**Justification for Class III Permit Modification**

**SWMU 37  
Operable Unit 1306  
PROTO Oil Spill**

**Solid Waste Management Unit 37  
Operable Unit 1306**

(RCRA Permit No. NM5890110518)

**Figure 9-2 showing laboratory and field screening samples**

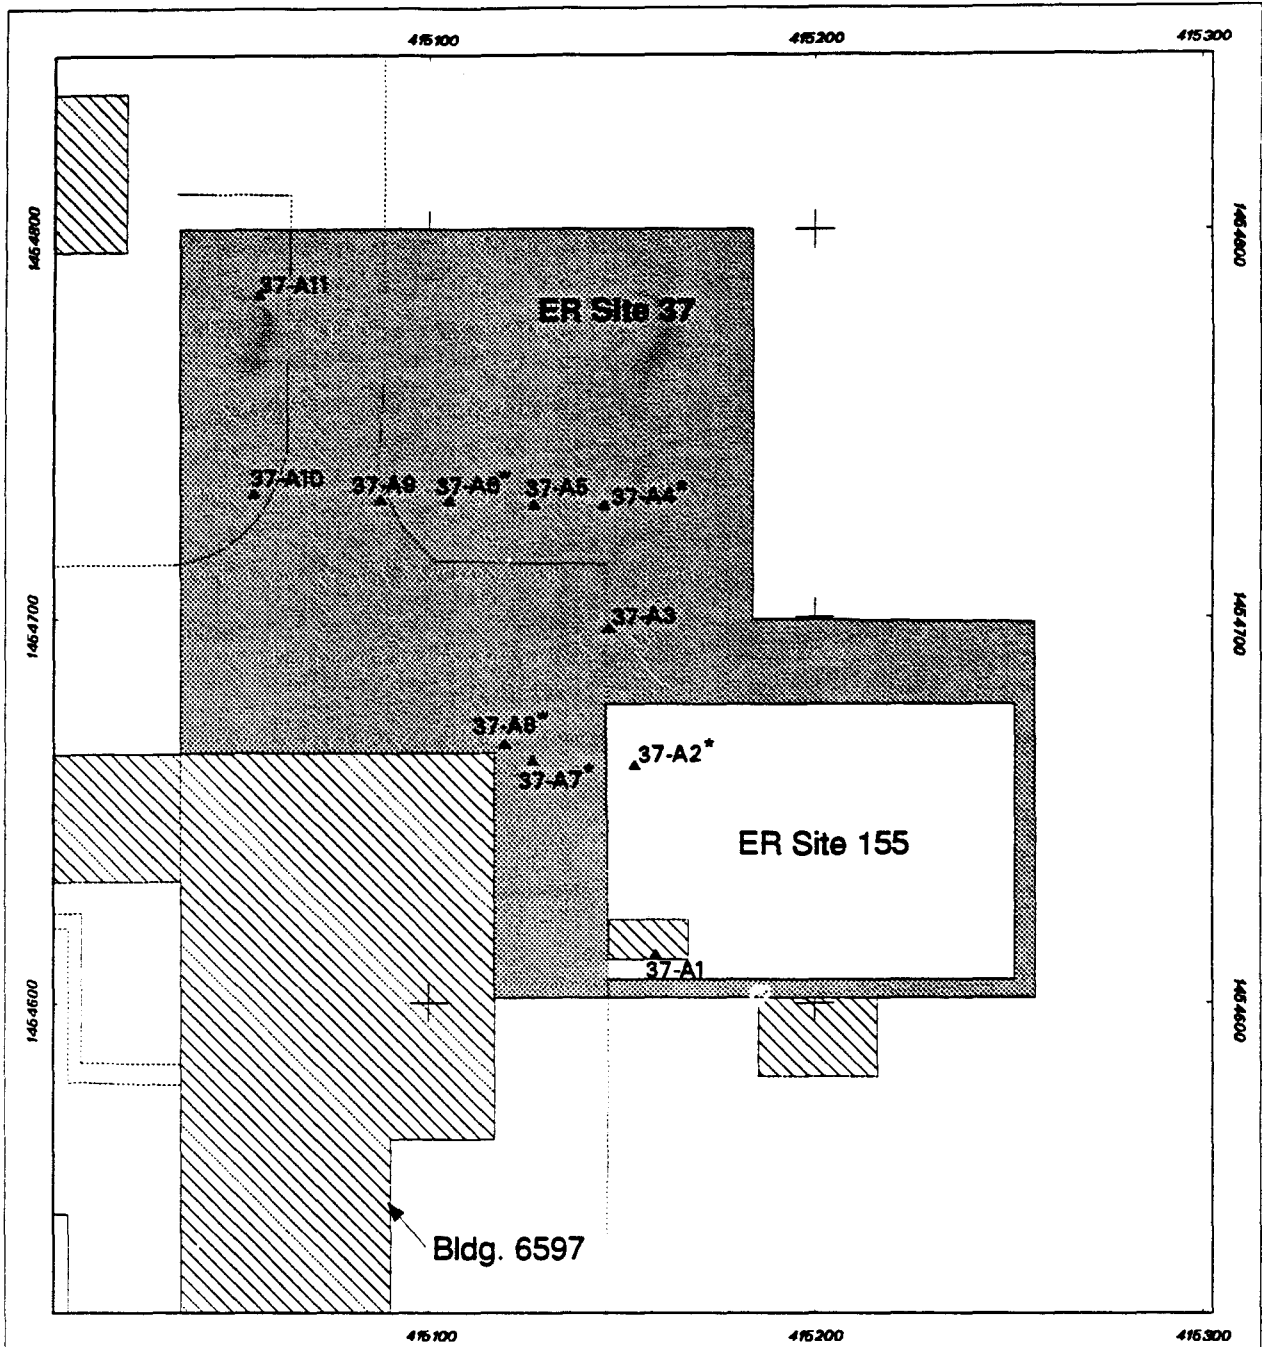
- 3. Page 9-3, Figure 9-2 -- A new map must be provided which differentiates between samples analyzed by field methods and those analyzed in the laboratory.**

Response: The table in Appendix B of the TA-III/V RFI Report compares the field screening analytical results to the laboratory analytical results for TPH and PCBs at Site 37. This table is presented in Attachment 37-3 of this NOD Response. The revised Figure 9-2 differentiates between samples analyzed by field methods and those analyzed in the laboratory. Samples analyzed in the laboratory were collected from locations A2,
